UNITED STATES PATENT AND TRADEMARK OFFICE

APPLICATION NO.	FILING DATE	FIRST NAMED INVENTOR	ATTORNEY DOCKET NO.	CONFIRMATION NO.
10/771,284	02/05/2004	Richard Assaker	64118.000046	3238

Office Action Summary

DETAILED ACTION

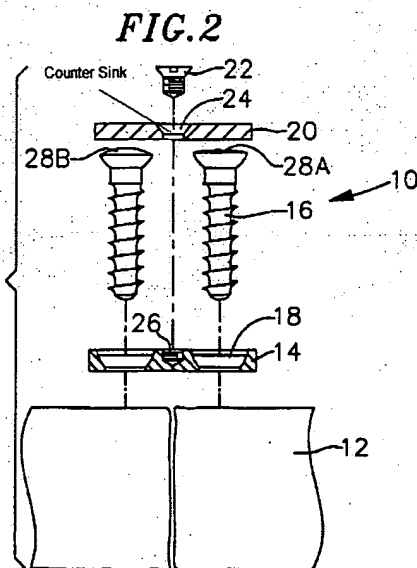
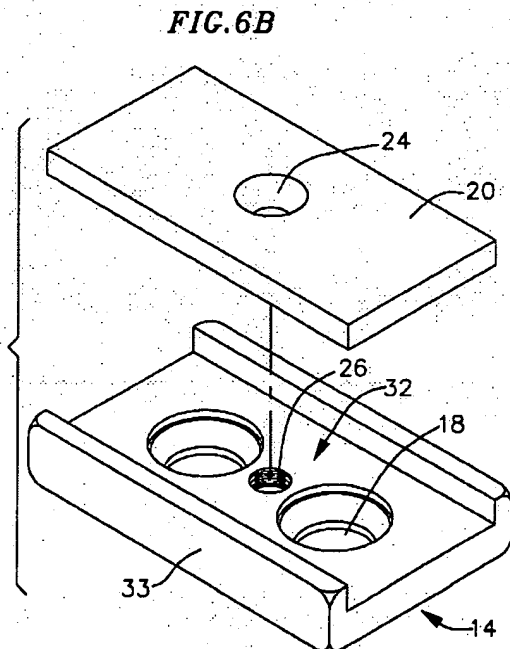
Bray discloses a bone plate assembly comprising: a fixation plate (14, Fig. 2 below) having a longitudinal axis along the plate, a locking plate (20, Fig. 2), and a bone fastener (16, Fig. 2) wherein the fixation plate is capable of being fixed by at least the bone fastener to a bone, and wherein the locking plate is capable of being secured to the fixation plate and is longitudinally adjustable along the longitudinal axis from a first position wherein the bone fastener can be fixed to the bone to a second position in which the bone fastener is locked into position by the locking plate. The locking plate could be slid back from the screw aperture (18, Fig. 2) (or even completely out of the hole), and the bone fastener can be placed through the screw aperture and placed into the bone. This can be considered the first position. The plate can then be slid back over the screw aperture and the locking plate can be locked. This can be considered the second position. The locking plate is capable of only limited vertical and longitudinal freedom relative to the fixation plate. When the screw is placed through the hole (24, Fig. 2) in the locking plate and is partially engaged with the screw aperture, the plate would still be able to move up and down relative to the plate and there would still be some play between the screw and the locking plate in the "longitudinal" direction. The longitudinal freedom is defined by a sliding connection between the locking plate and the fixation plate. The locking plate is able to slide relative to the fixation plate. The fixation plate has a bottom surface, which faces the bone, and a top surface spaced therefrom (Fig. 2), and the sliding connection is formed by providing opposing shoulders

(33, Fig. 6B below) in the top surface of the fixation plate so as to define a guide way (32, Fig. 6B) for the locking plate. The vertical freedom is defined by a lock screw (22, Fig. 2), which extends through an opening (24, Fig. 2) in the locking plate to secure the locking plate to the fixation plate. The distance between the first position and the second position defines a longitudinal play and the opening in the locking plate is a slot (24, Fig. 2) having a first end opposing a second end which together define the longitudinal play of the locking plate relative to the fixation plate. The locking plate has an exterior surface (Fig. 2) and the slot includes a counter sink (Figs. 2 and 3 below). The locking plate has an exterior surface (Fig. 2) and the slot includes a counter sink (Fig. 2 below), and the lock screw is capable of sinking substantially flush with the exterior surface of the locking plate (Fig. 3 below). The lock screw extends through a hole in the fixation plate (24, Fig. 2), and further has means to restrain it from exiting the threaded hole of the fixation plate. The means can be considered the threads of the bone screw, and the head of the screw, which frictionally engages the opening in the locking plate. The locking plate can simultaneously lock multiple bone fasteners into position. The plate can lock at least two in position, as seen in Fig. 6B. The bone fasteners are screws (28B and 28A, Fig. 2). At least two bone fasteners (28B and 28A, Fig. 2) are included and the locking plate and can simultaneously lock all the bone fasteners of the fixation plate. The plate can lock both screws at the same time when the locking plate is locked into position. A plurality of bone fasteners (28B and 28A, Fig. 2) are used in the bone plate assembly, and all of the bone fasteners of the fixation plate are aligned to enable them to be locked by the locking plate. Two points form a line, and the two screws are in

two points in the plate, hence they are aligned. They are capable of being locked into the plate at the same time, as already discussed. The two screws are in alignment. The locking plate includes at least one opening (24, Fig. 2) which is capable of accepting a bone fastener, and which is further capable of being concentrically aligned with at least one opening for a bone fastener in the fixation plate when the locking plate is in a first position. The holes could be placed one above the other in the first position, before the locking plate is locked in the second position. Bray further discloses an implant for the spine, comprising: a plate for stabilizing the spine (14, Fig. 2), the plate having a number of openings (18, Fig. 2); a number of bone anchorage screws (28B and 28A, Fig. 2) each capable of engaging a corresponding one of the openings of the plate; and means for blocking the screws including at least one slide (20, Fig. 6B) which can be mounted on the plate to selectively cover at least a part of at least one of the screws. When the locking plate (20, Fig. 6B) engages the fixation plate (14, Fig. 6B), the plate can cover the top of the screws. Bray discloses means for retaining the slide on at least one of the screws, which is the lock screw (22, Fig. 2) along with the threaded hole (26, Fig. 6A) of the fixation plate. The slide is capable of cooperating with the retaining means, since the slide has a hole (24, Fig. 2). The plate defines a cavity (32, Fig. 6A) and the slide is capable of being mounted within the cavity (Fig. 3).

FIG. 8

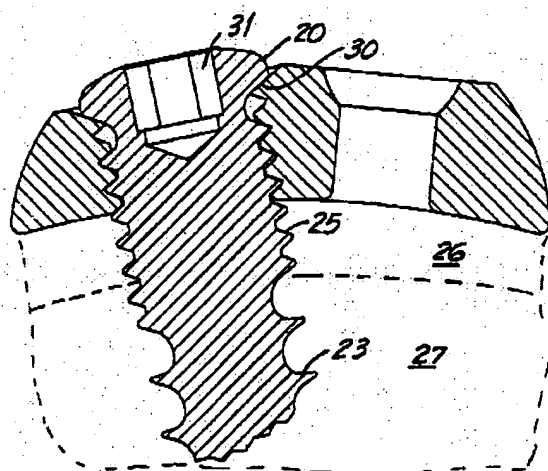
Trebing et al. disclose a locking plate having a threaded bore (30, Fig. 8 below), used for engaging the screw head to prevent back out (column 1, lines 35-39).

It would have been obvious to a person having ordinary skill in the art at the time the invention was made to have modified the locking plate of Bray with the threaded bore of Trebing et al, in order to better secure the screw to the plate (column 1, lines 35-39).
